South Coast Air Quality Management District

E-MAILED: JANUARY 25, 2013

**Draft Initial Study/Mitigated Negative Declaration (Draft IS/MND) for the
Proposed Transfer Station Project: East Los Angeles Recycling & Transfer Station.**

WIND ROSE PLOT:
Central LA

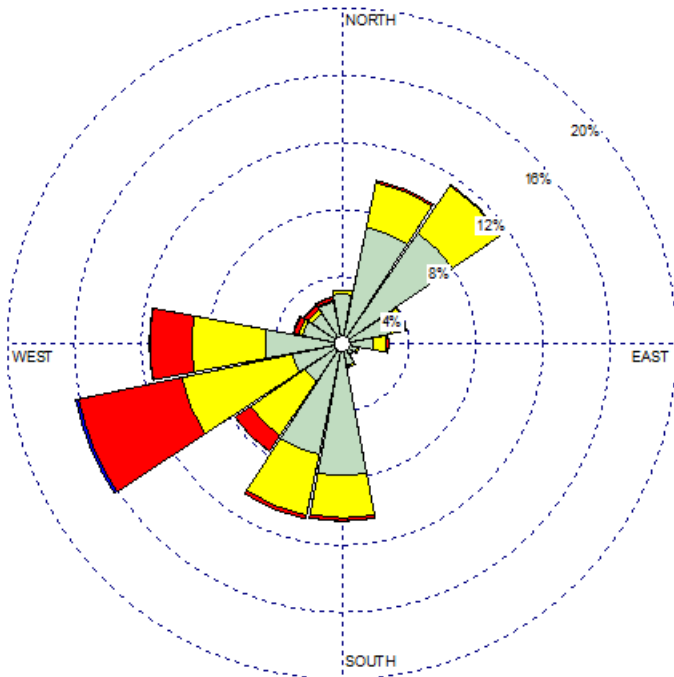
- The study would have benefitted by including an historical wind rose and an analysis of daily and yearly wind patterns and their relation to receptors, particularly residential. The Central Los Angeles Annual Wind Rose is included on page seven for the lead agency’s convenience.
